DATE: July 25, 2025
TO: ALL CONTRACTORS
FROM: ROBBIE STROM
PROJECT: ALOE BAY HARBOR TOWN PHASE II – PACKAGE I DESOTO AVENUE BOARDWALK & BULKHEAD #M1A101-ABHT FOR THE TOWN OF DAUPHIN ISLAND GMC PROJECT NO. CMOB220084(1)
RE: ADDENDUM #1

ADDENDUM NUMBER 1

ALOE BAY HARBOR TOWN PHASE II – PACKAGE I DESOTO AVENUE BOARDWALK & BULKHEAD #M1A01-ABHT
FOR
TOWN OF DAUPHIN ISLAND
GMC PROJECT NO. CMOB220084(1)

2. Revisions to Plans

C9
sheet_of

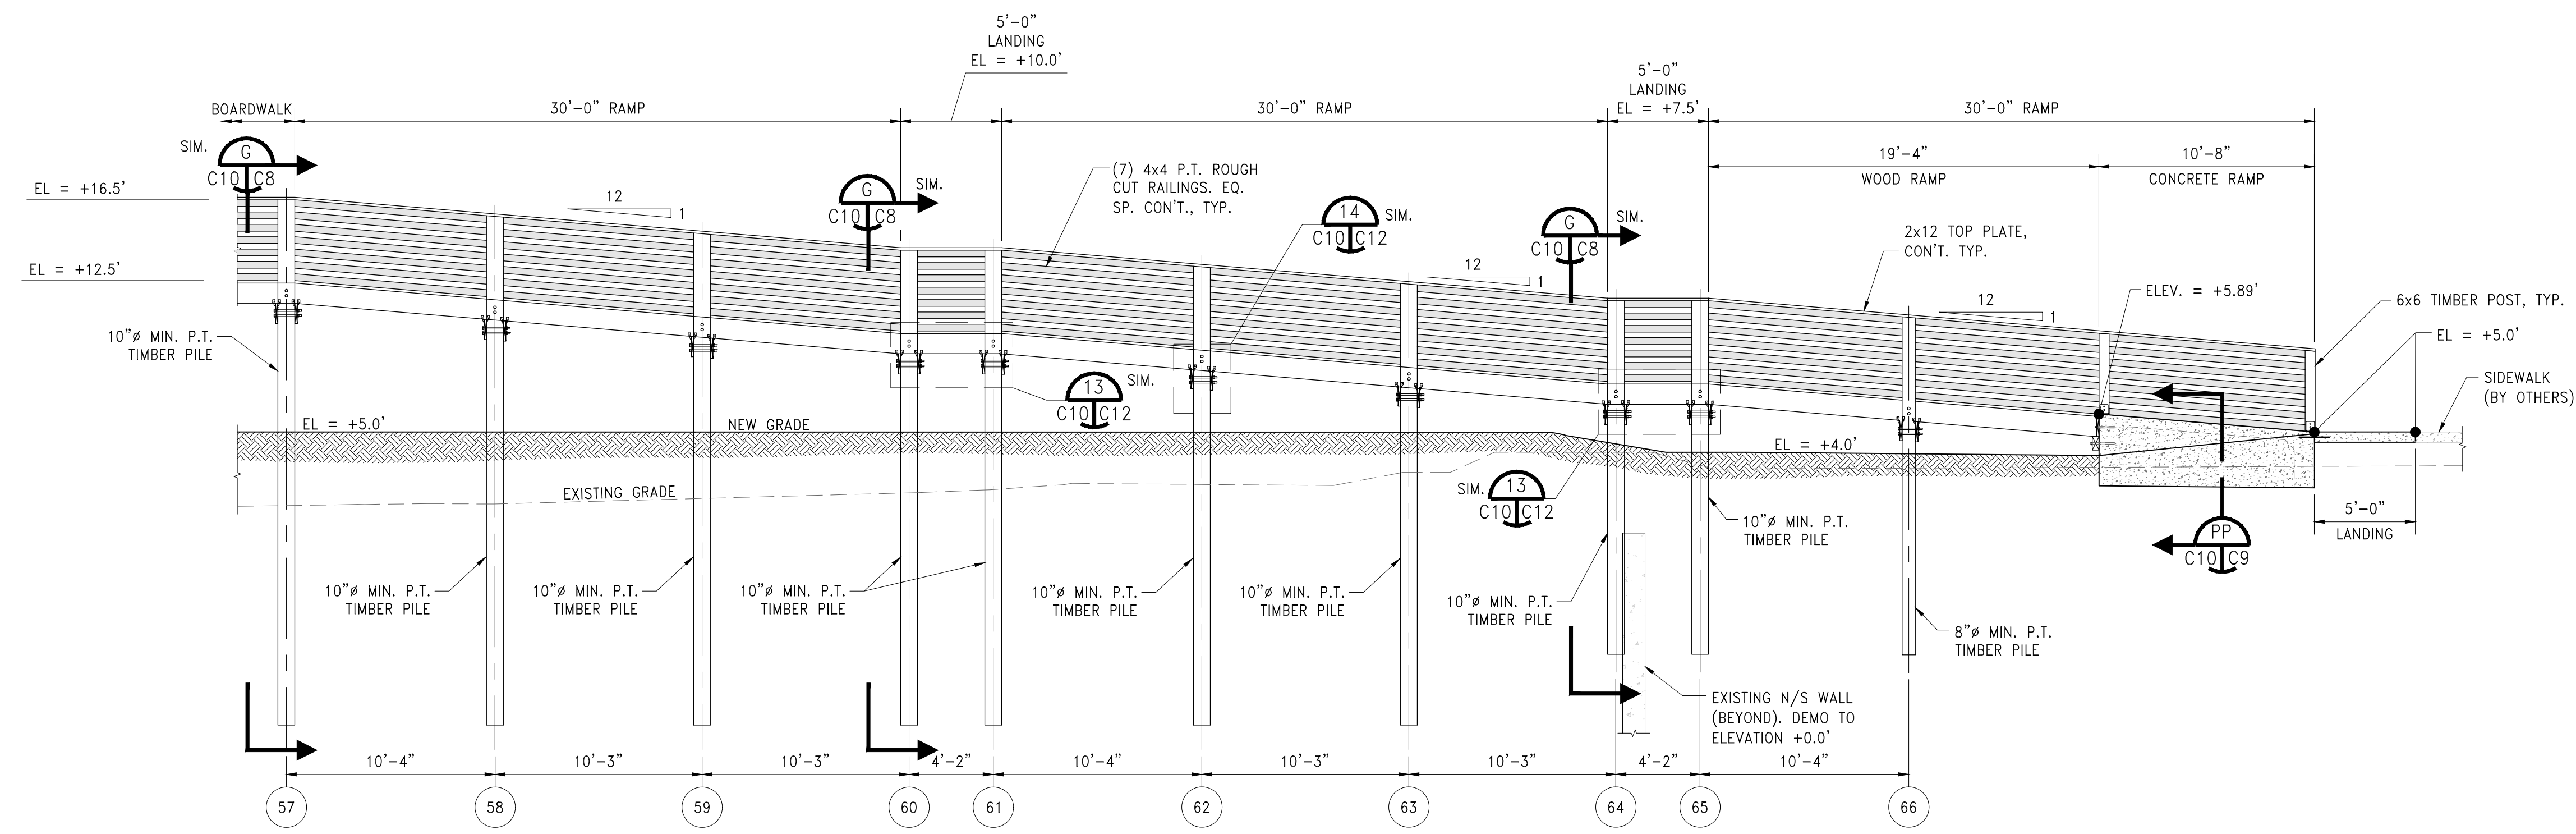
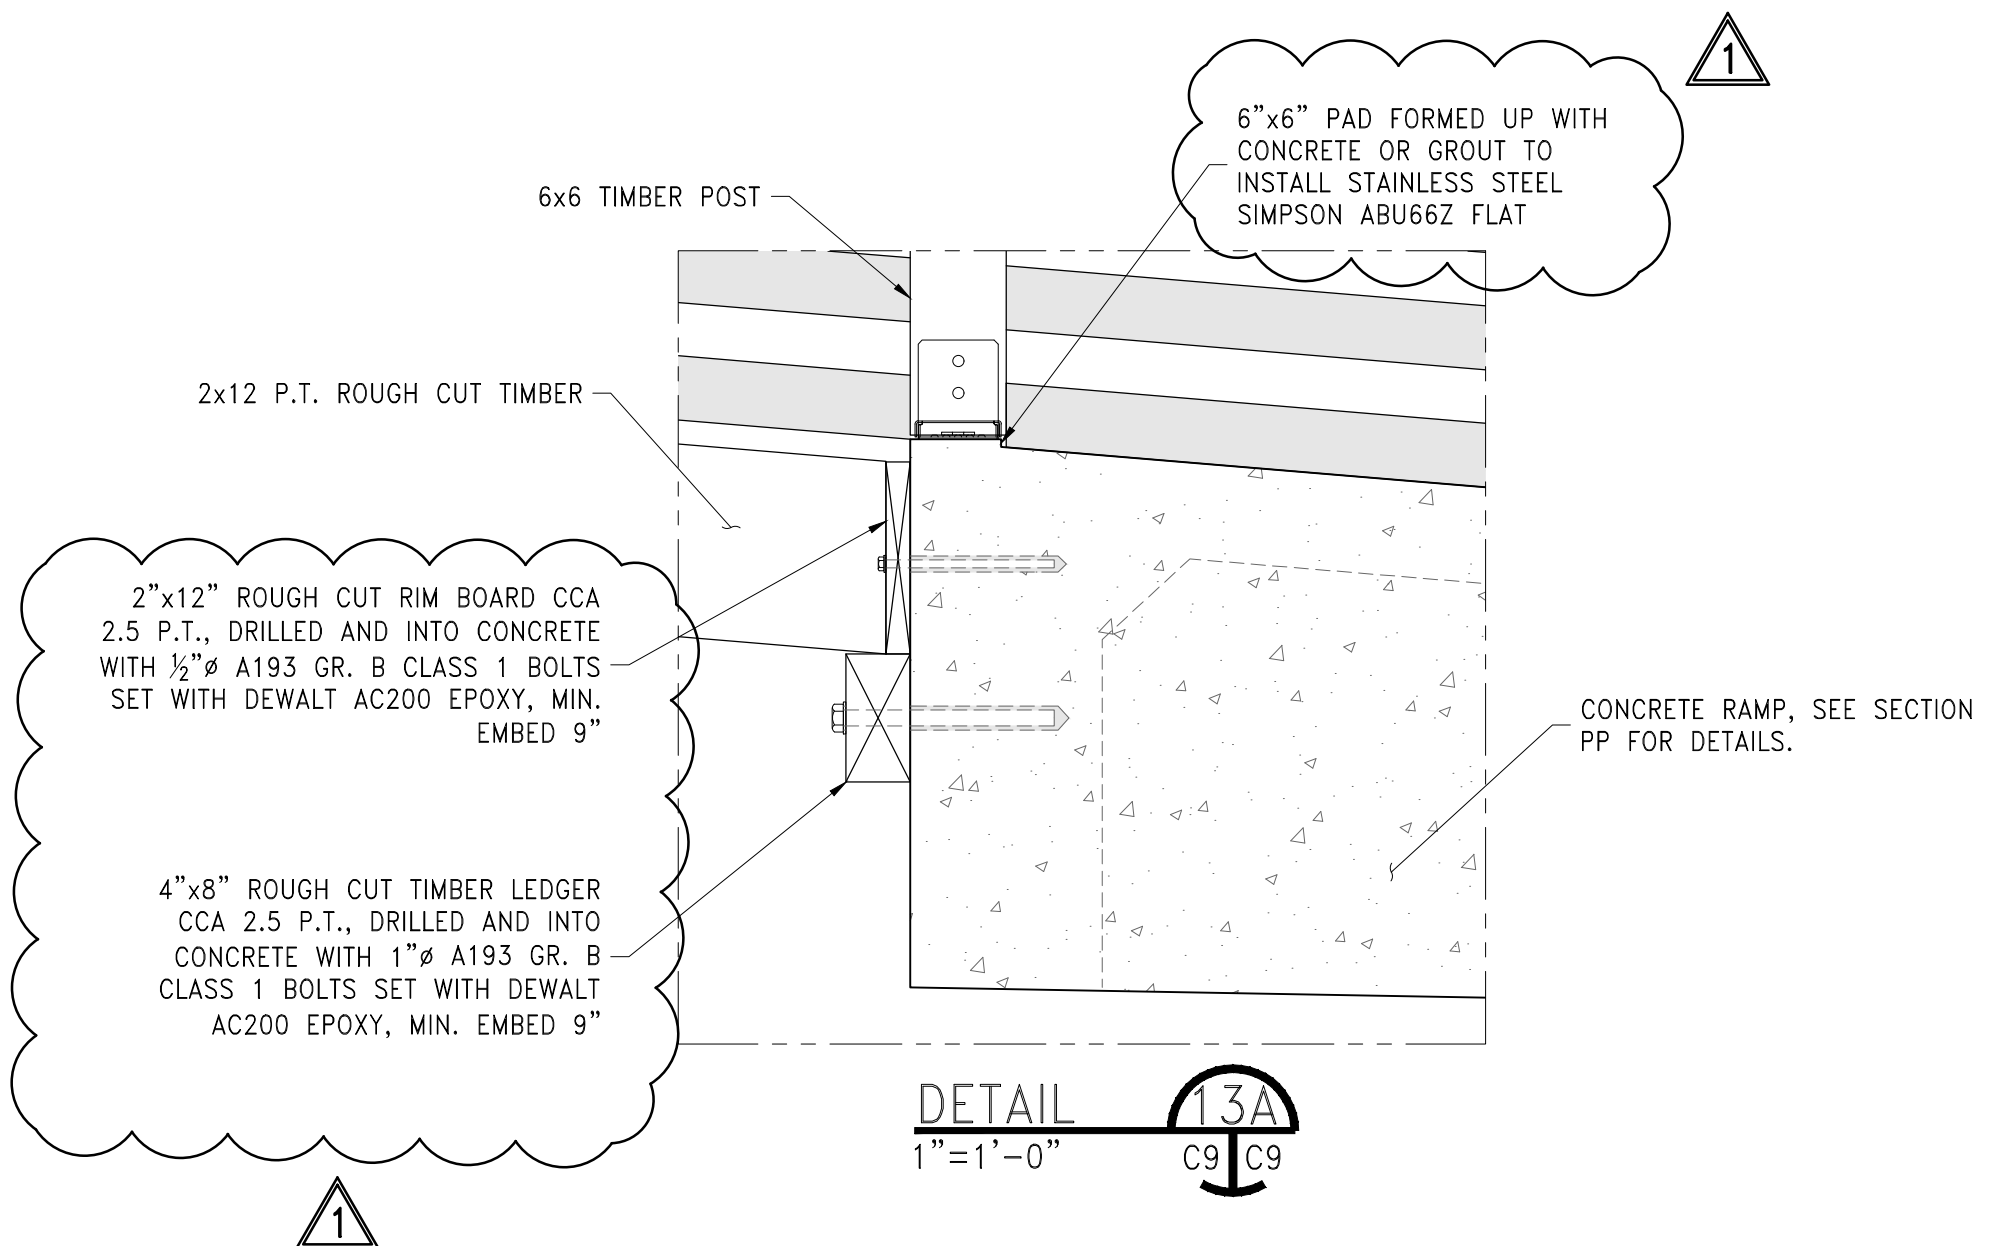
- 4.13 **The piling layout plan shows the 97' ramp pilings to be 8". The ramp profile and detail on C10 shows the pilings to be 10". Please advise which is correct.** The 97' ramp piling shall be 8" tip. The information on C10 is not for the 97' ramp. The 97' ramp section is on C9.

PIPE PENETRATION COLLAR PLATE DETAIL
3/8"=1'-0"

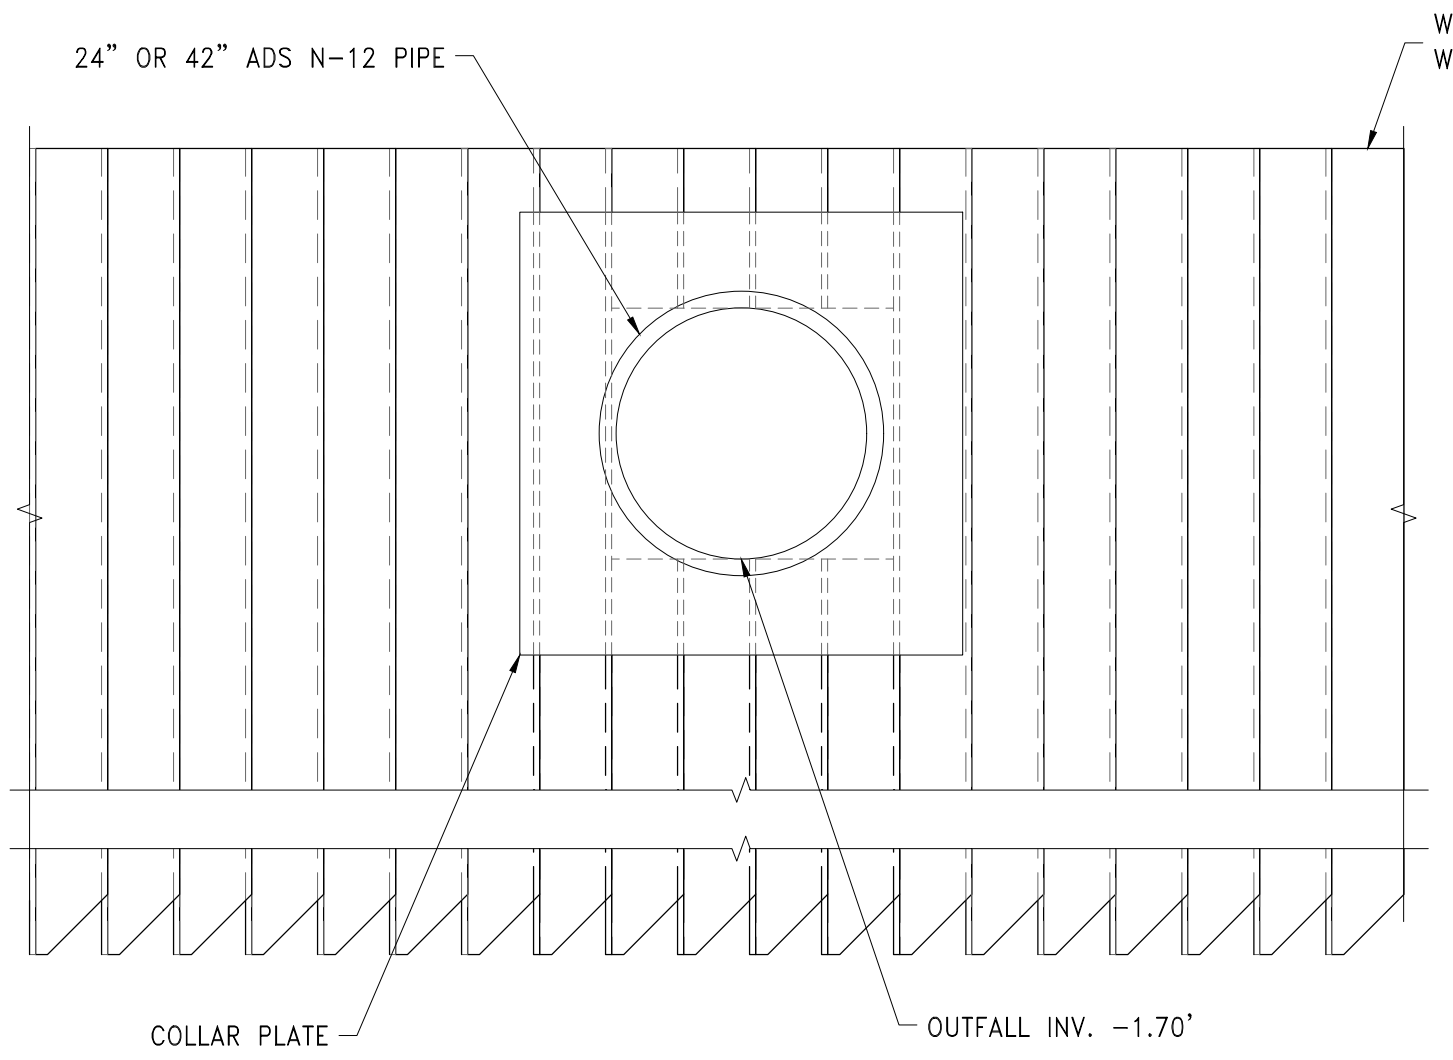
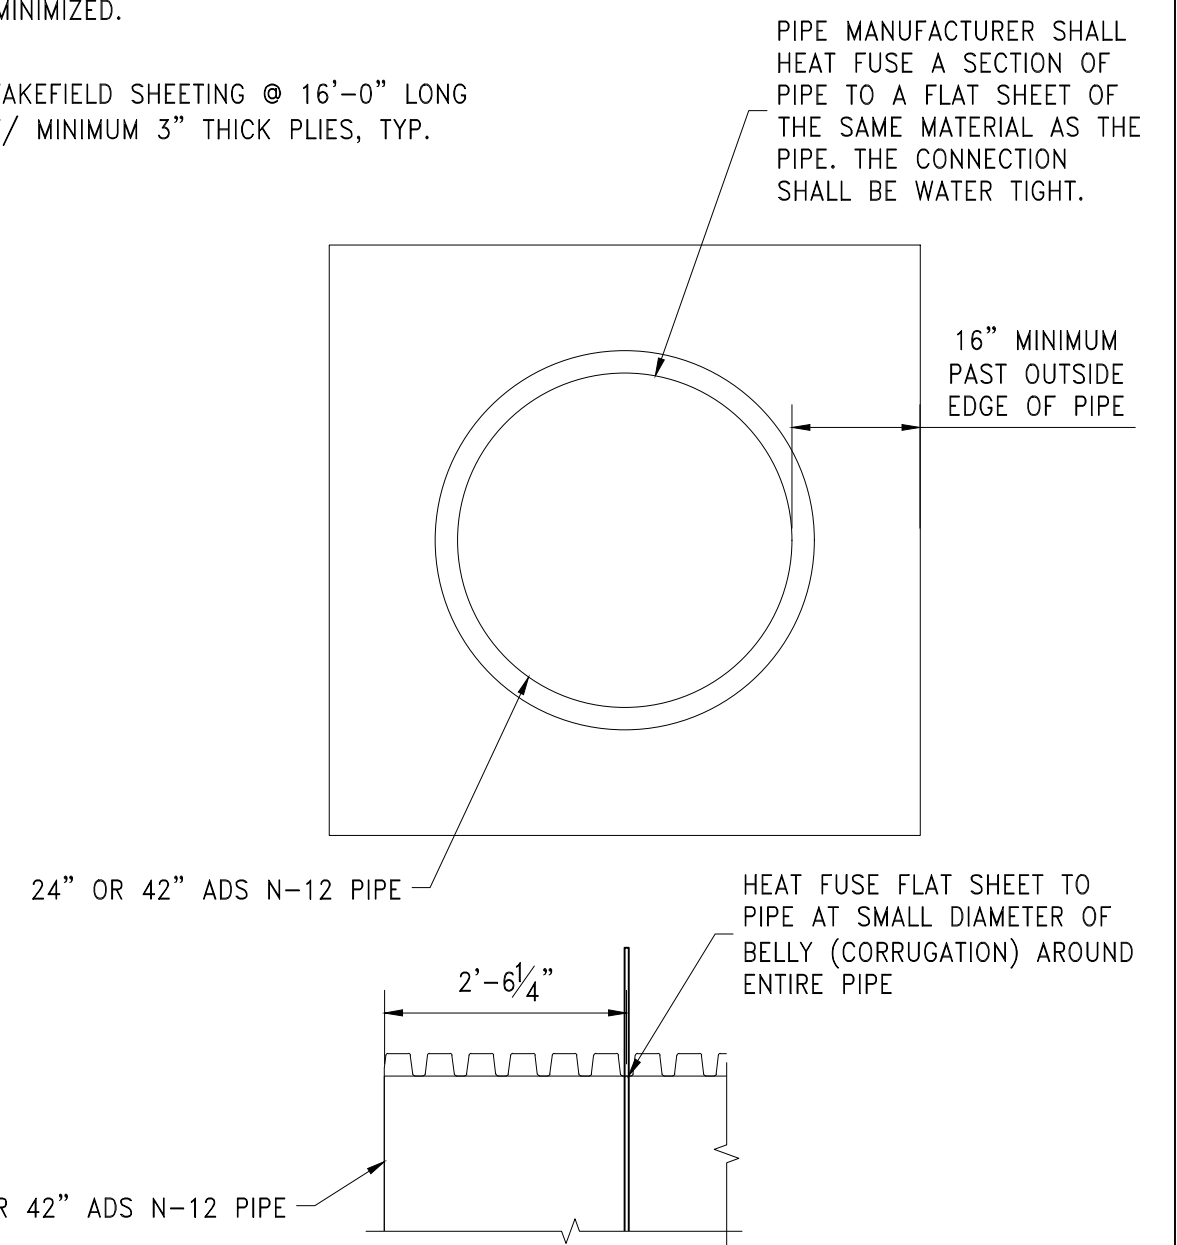
- 4.14 **The pipe manufacturer and pre-cast supplier is requesting more detail and design information on the collars and the pre-cast panels. Do you have any more information on those items?** Additional clarification is needed in order to address the question. The precast manufacturer will be responsible for the design of the panels.
